**City of Kodiak**  
**Kodiak Police Department Security Controls Upgrade PN 22-07/4068**  
**Addendum No. 3**  
**June 20, 2022**

# Administration Control Screen

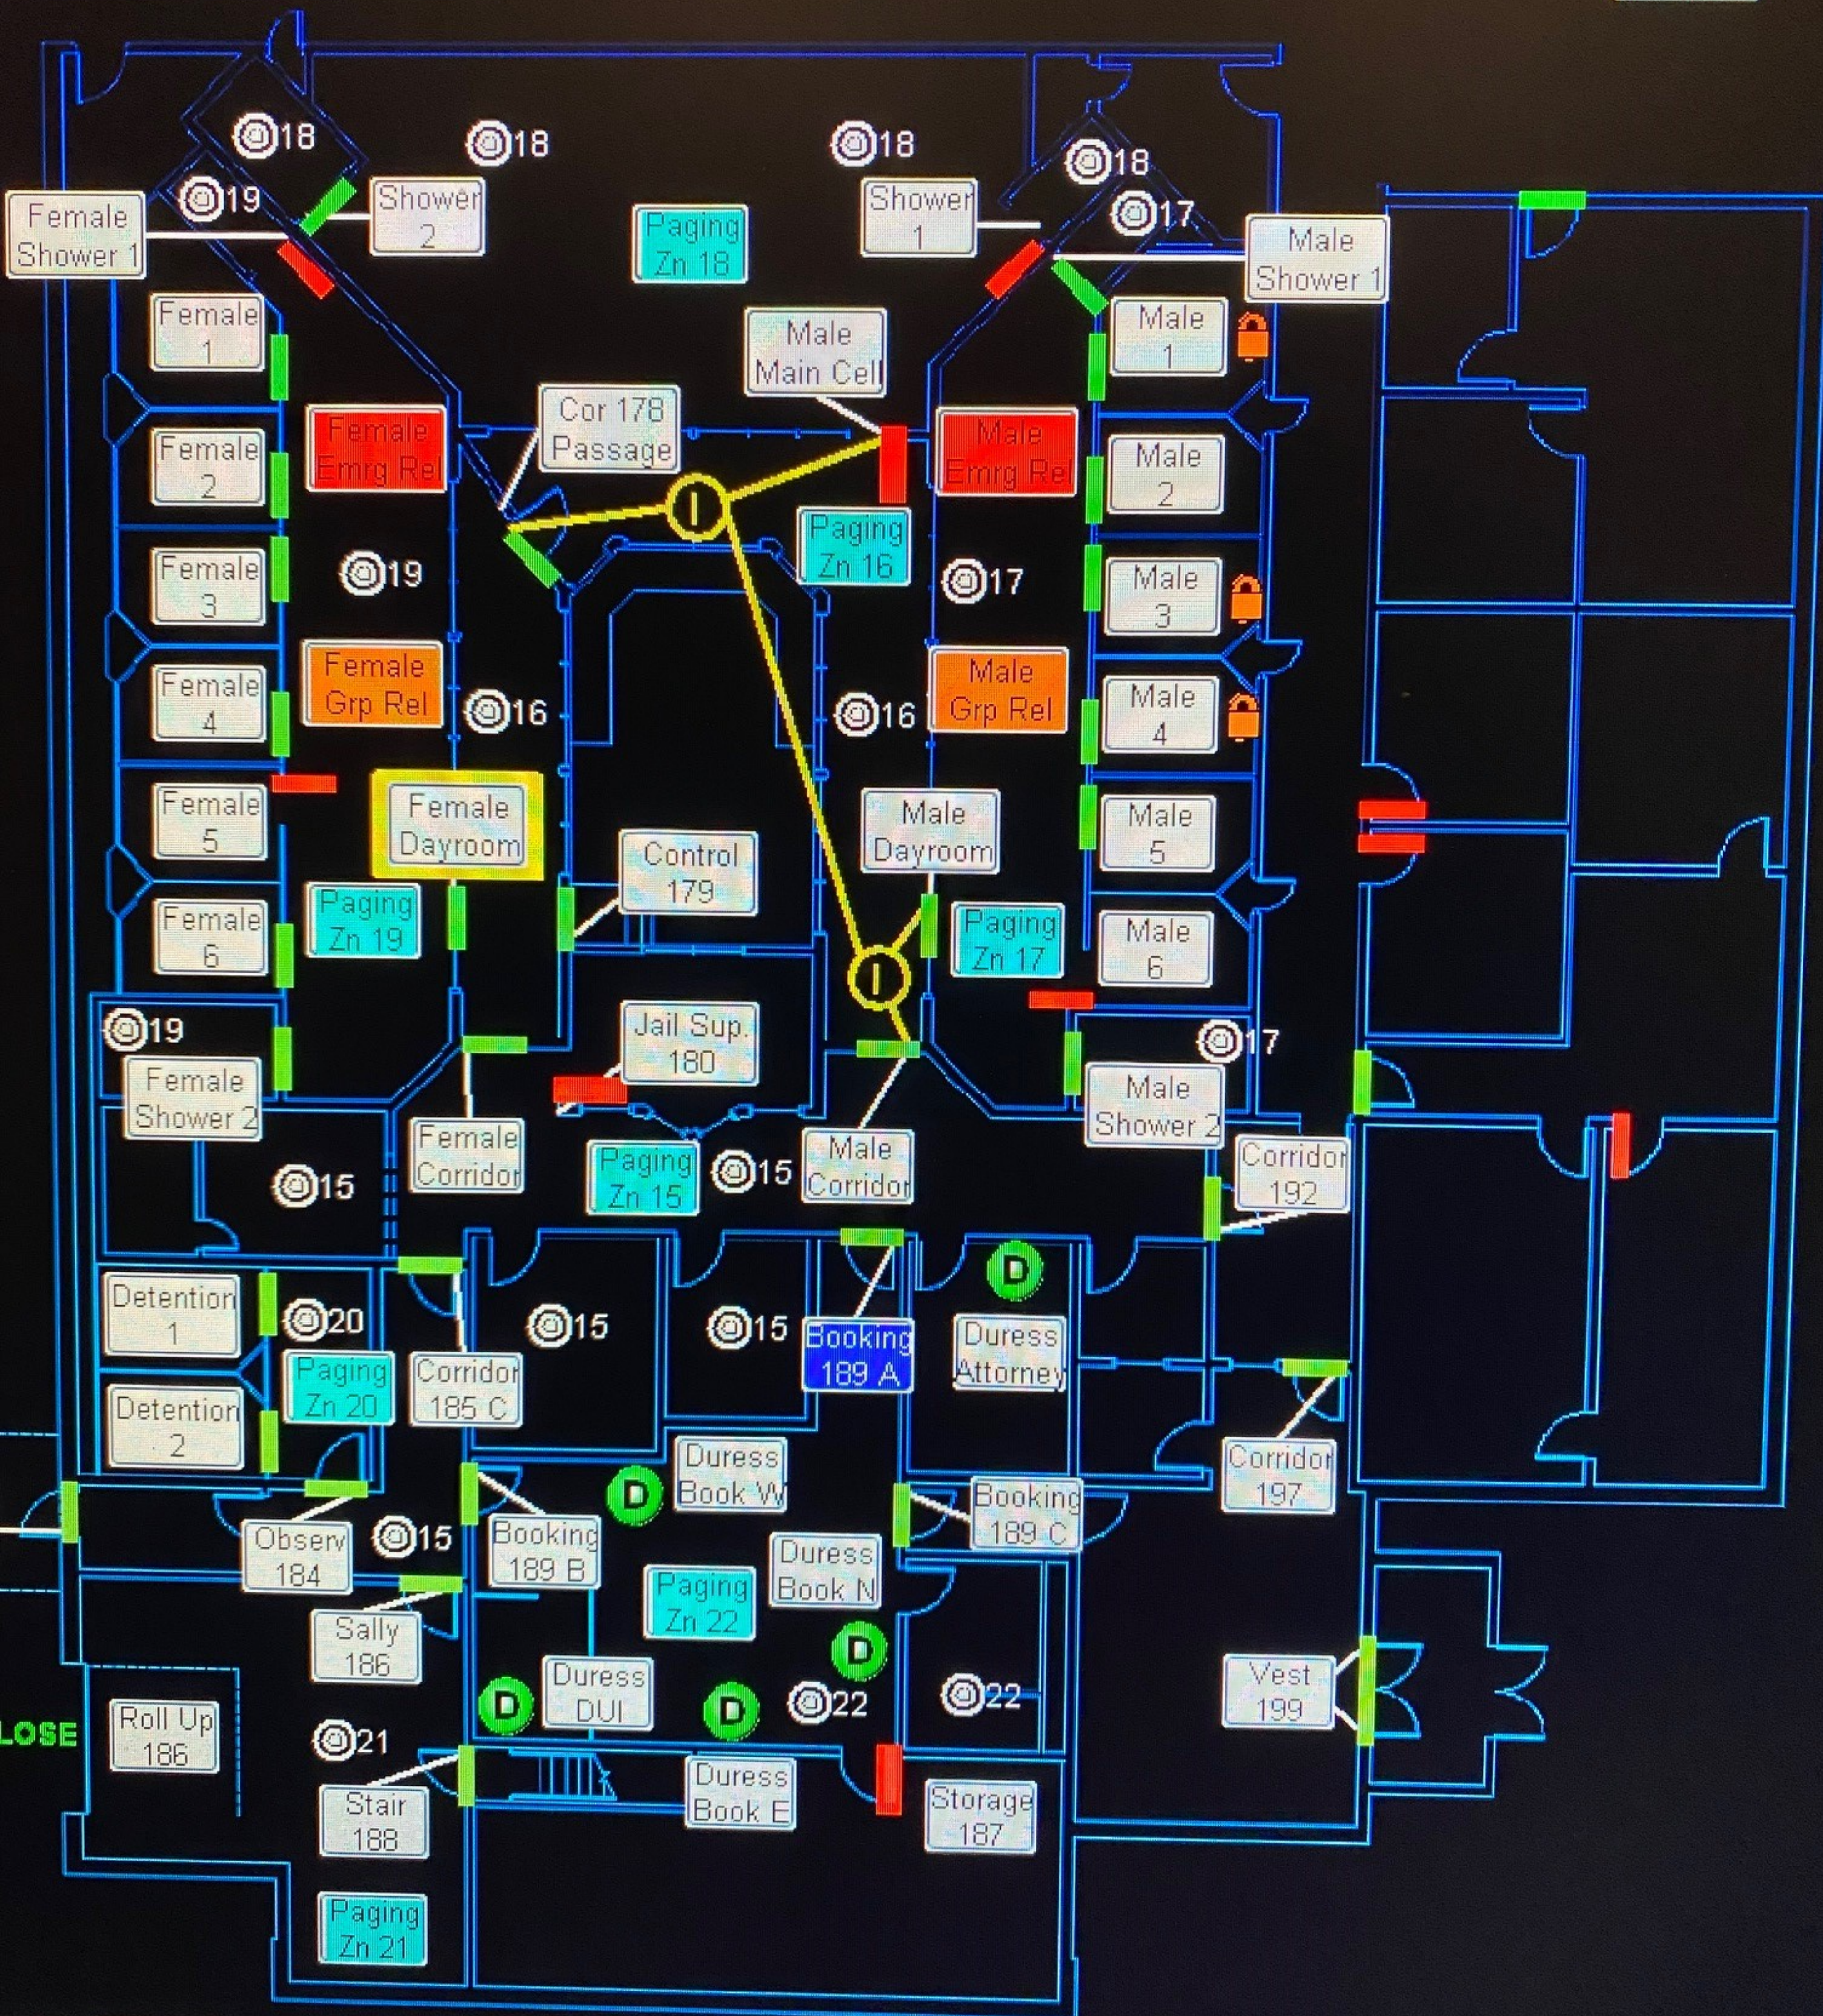
c) Would it be possible to provide screen shots (pictures) of all current locking control screens? This will aide in understanding current system control / monitoring field devices and a better path for GUI tag counts

Answer: Screen shots (3) are attached.
